SAN FRANCISCO PLANNING DEPARTMENT

Certificate of Appropriateness Case Report

Filing Date: July 12, 2012
Case No.: **2012.0884A**
Project Address: **4701 3rd STREET (BAYVIEW OPERA HOUSE)**
Historic Landmark: Landmark No. 08
Zoning: P (Public) Zoning District
40-X/OS Height and Bulk District
Block/Lot: 5311/036
Applicant: Judy Nemzoff, San Francisco Arts Commission
25 Van Ness Avenue
San Francisco, CA 94102
Staff Contact Richard Sucre - (415) 575-9108
richard.sucre@sfgov.org
Reviewed By Timothy Frye – (415) 575-6822
tim.frye@sfgov.org

2 (N) SECTION @ SOUTH WALL
3/4" = 1'-0"

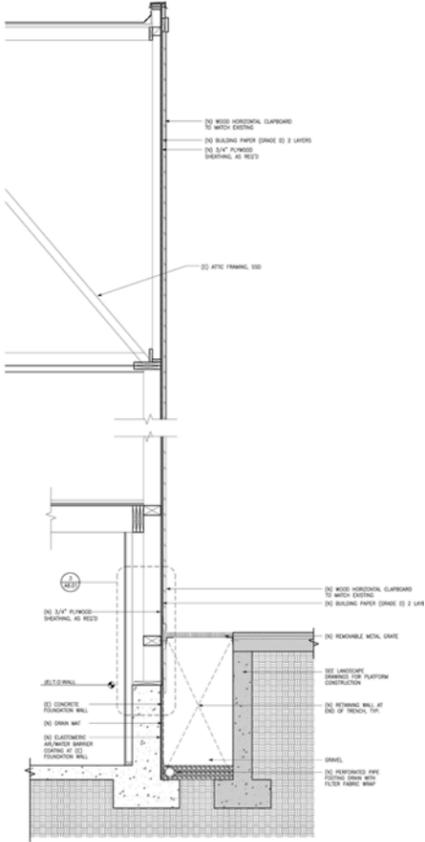
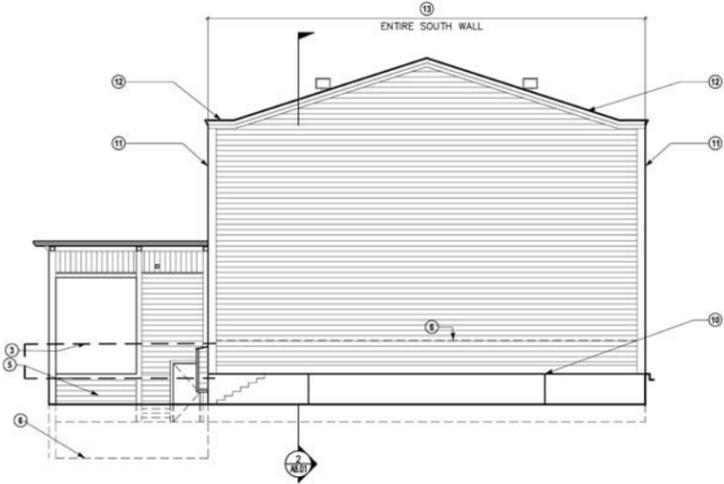
Recladding of Rear (South) Façade: Department staff finds the replacement of the stucco cladding on the rear façade with new wood siding to be an appropriate treatment, since this material is not original to the landmark property and the new wood siding would match the existing historic wood siding in size, form, and detail.

ELEVATED GLASS WALKWAY

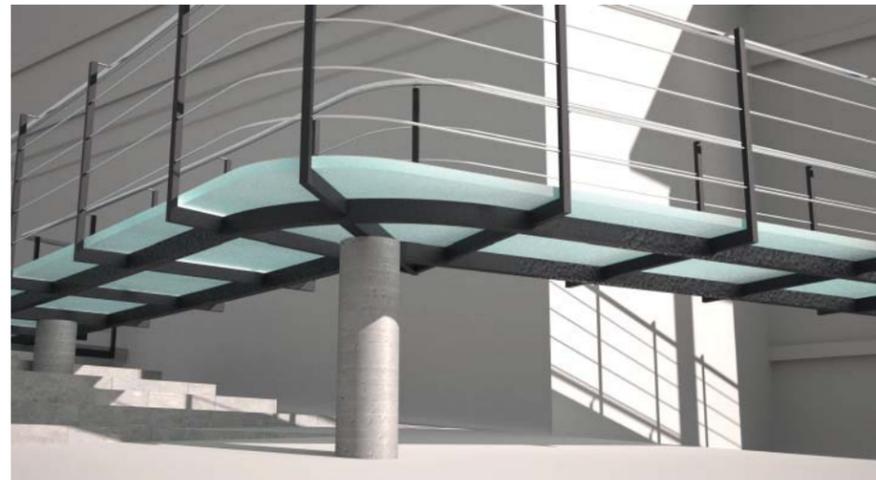
1. Prior to approval of the Site Permit, the flooring of the proposed handicap accessible walkway shall be constructed of painted wood or painted metal. The existing fritted glass material is not compatible with the landmark property. The Project Sponsor shall provide a material sample, updated plans, elevations and details of the ramp and flooring to Planning Department Preservation Staff for review and approval.
2. Prior to approval of the Site Permit, the Project Sponsor shall provide detailed information on the new wood siding on the rear facade for review and approval by Planning Department Preservation Staff. Specifically, the Project Sponsor shall provide a material sample, updated elevations and details of the siding. The new wood siding shall match the historic wood siding in form, detail, and material.
